Drainage Technical Note 01 (to discharge Planning Condition 10)

Sytner Group Porsche, Mid Sussex, London Road, Sayers
Common, Hassocks BN6 9HS

Project Number	Document Reference	Revision
23-0466	230466-ROL-ZZ-XX-RP-C-0001	S2-P01

This Technical note has been prepared to discharge planning condition 10 for the proposed new Porsche dealership at London Road, Sayers Common, Hassocks BN6 9HS as identified on Lead Local Flood Authorities (LLFA) review letter ref. 'P269 UPDATED FILE NOTE 4th July 2025, recreated as follows;

Drawing Title:
Proposed Catchment Area Plan

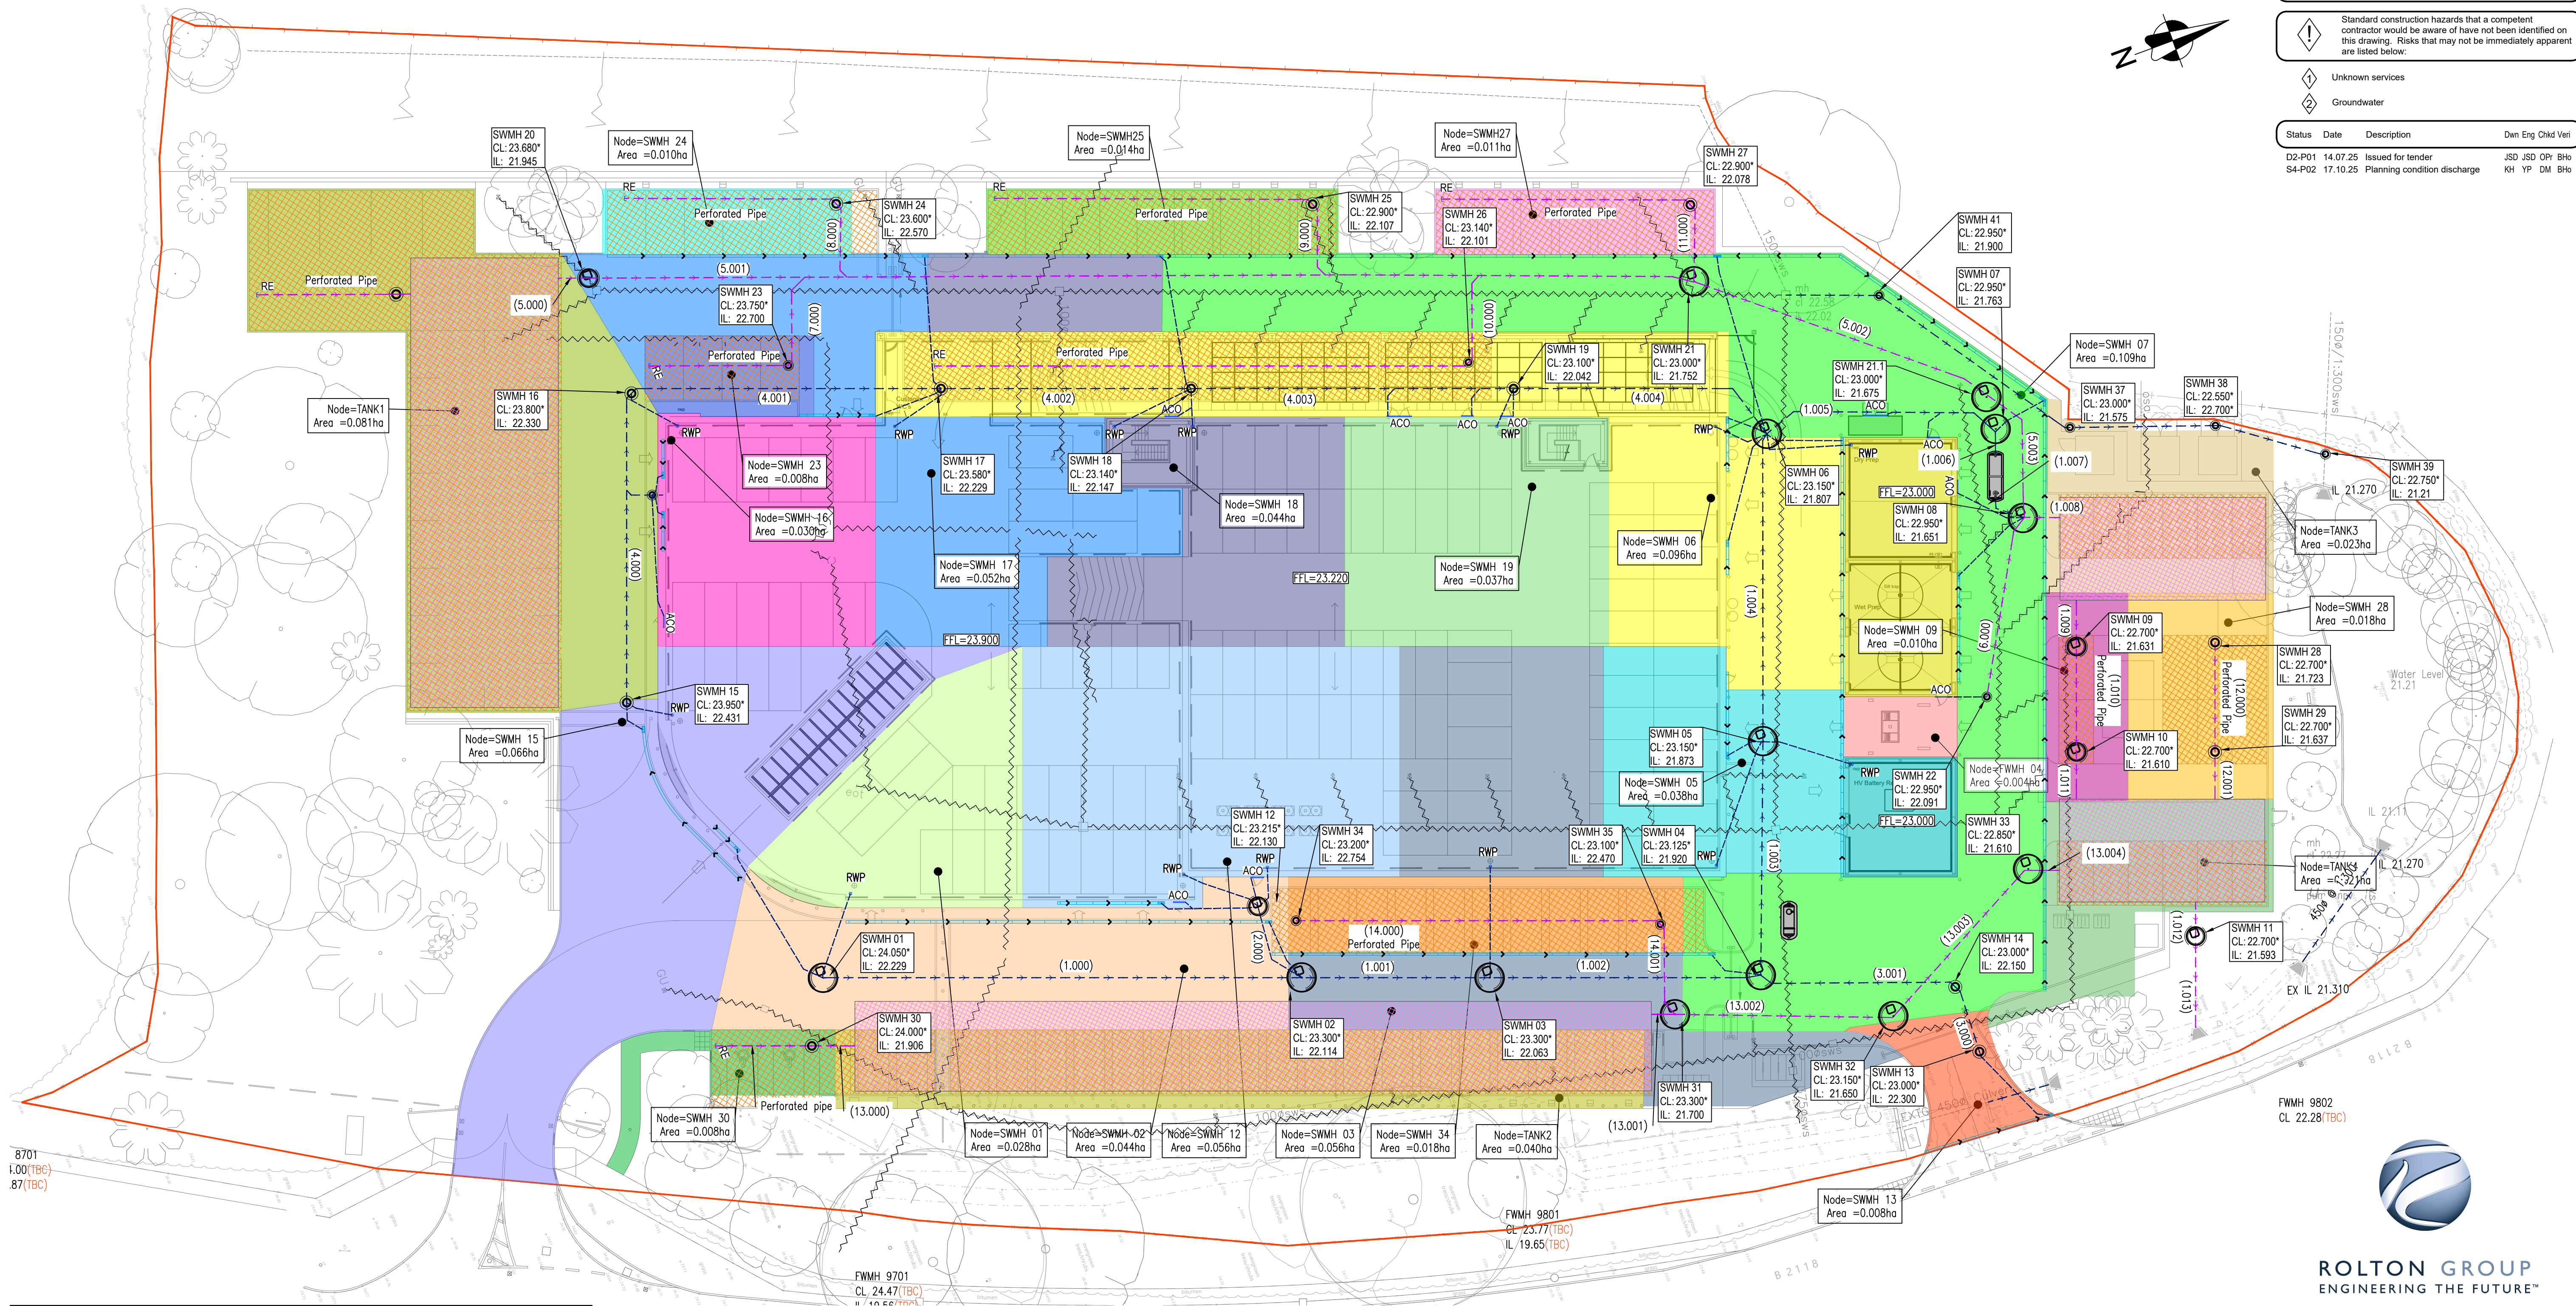
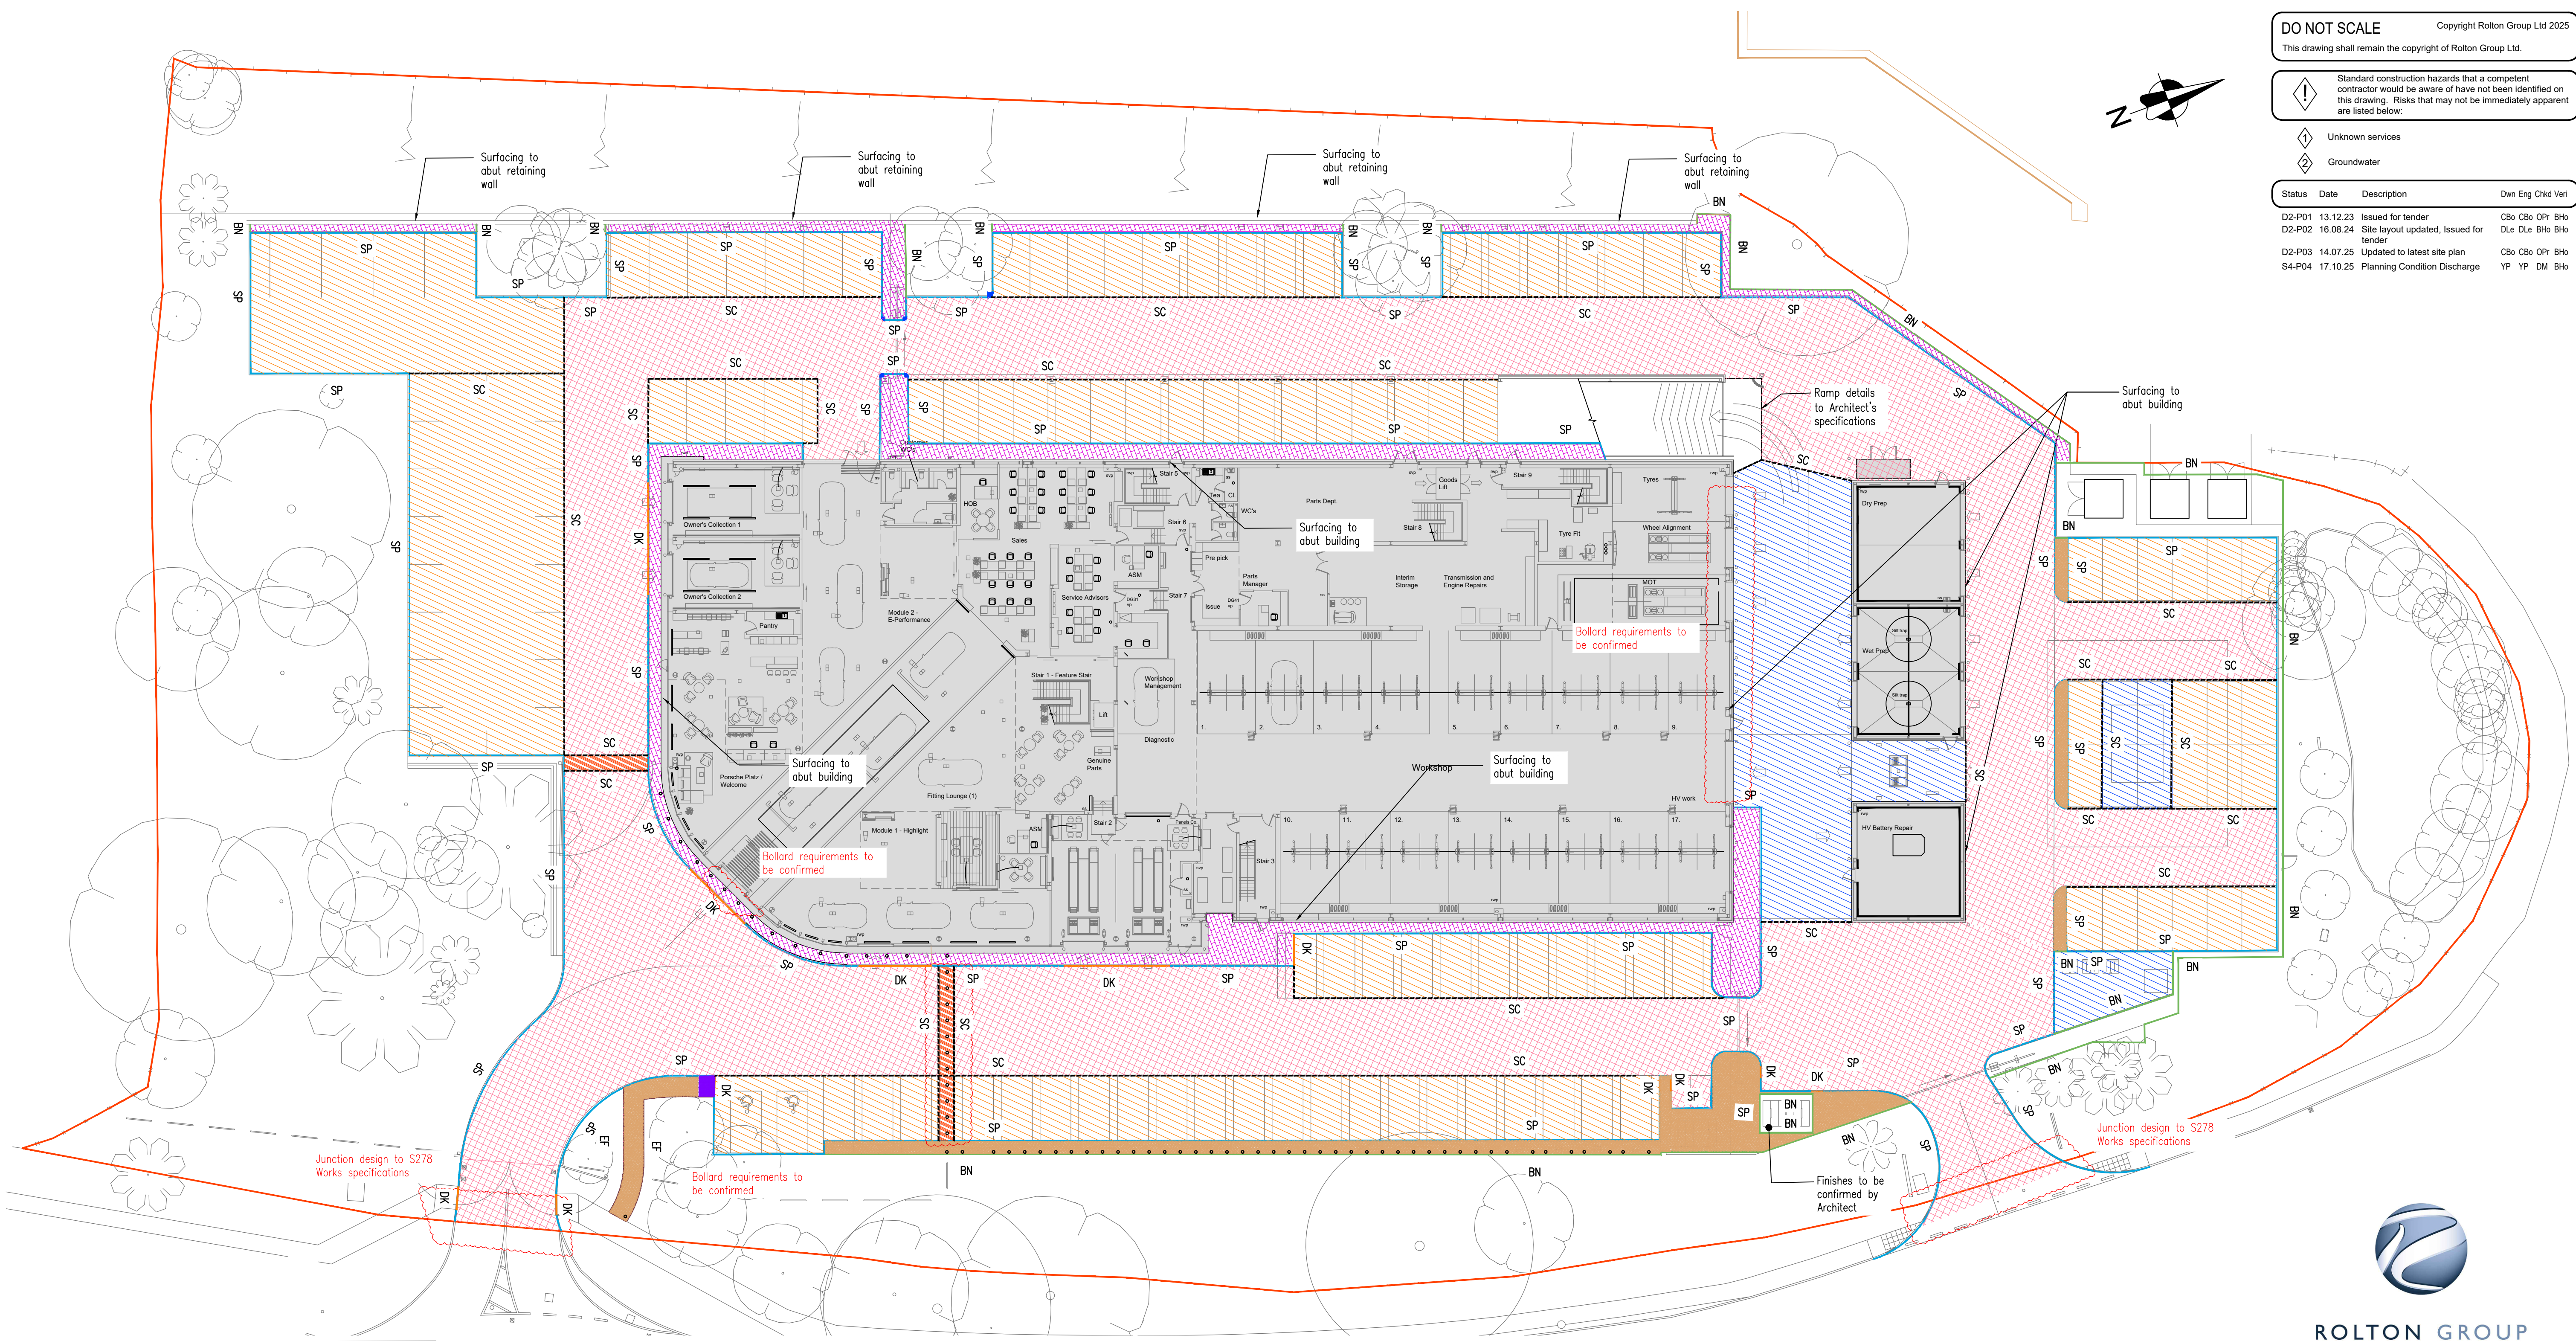
- Reviewer's comments:
The discharge rate should be as close to the greenfield runoff rate for the area of the site being attenuated as feasible
- Response:
The approved Flood Risk Assessment and Drainage Strategy (Doc Ref: 101/R001) calculates a greenfield rate of 5.168 l/s/ha. For a proposed catchment area of 0.930 ha, a proposed discharge rate of 4.80 l/s has been calculated.

Catchment Area (ha)	Impermeable Area (ha)	Direct Discharge location
Catchment 1	0.930ha	To existing retained ditch.
